Report: TAB Report
Function: Test, Adjust, & Balance
Date: 01/16/2026
Completed By: National TAB

PROJECT
01-26-26 QT #1114 GREER, SC

Project: 01-26-26 QT #1114 GREER, SC

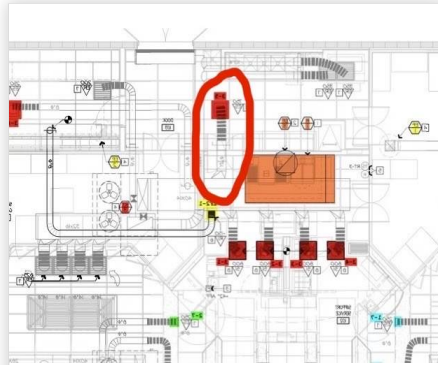
Issue Name : Damper 3-5 Not Accessible
Description : The damper for 3-5 is not accessible. It is located in an area where it cannot be reached.
Created By : National TAB **Assigned To :** National TAB - Dan Hertenstein
Status : Open
Priority : High **Asset Tag :** SGRD5
Originated Date : 01/28/2026 - Alex Bauer - National TAB

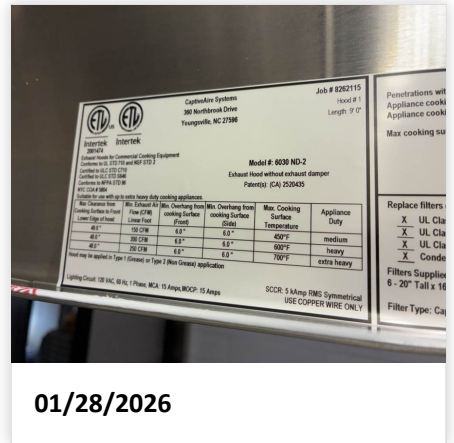
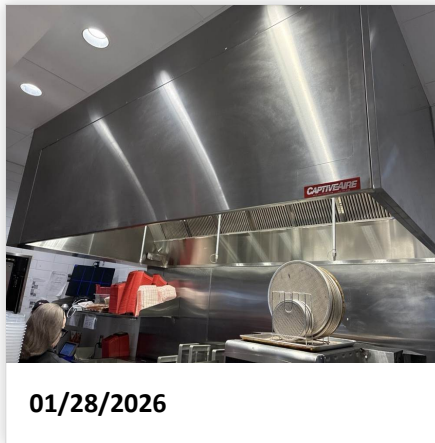
Issue Name : No Hood End Panels Installed
Description : There are no hood end panels installed as per the Hood Schedule.
Created By : National TAB **Assigned To :** National TAB - Dan Hertenstein
Status : Open
Priority : Medium **Asset Tag :** HD1
Originated Date : 01/28/2026 - Alex Bauer - National TAB

Unit Data - PHOTO LOG

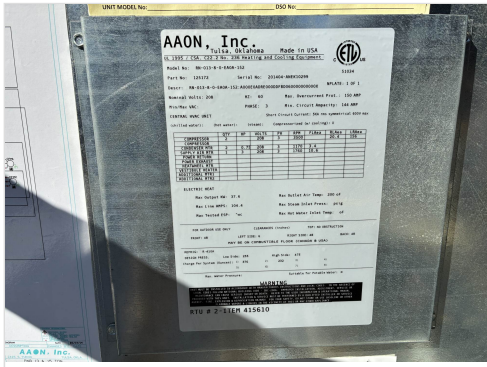
Dampers 3-1 through 3-4 were not accessible. The ceiling tiles were not able to be moved. Damper 3-5 is not accessible.
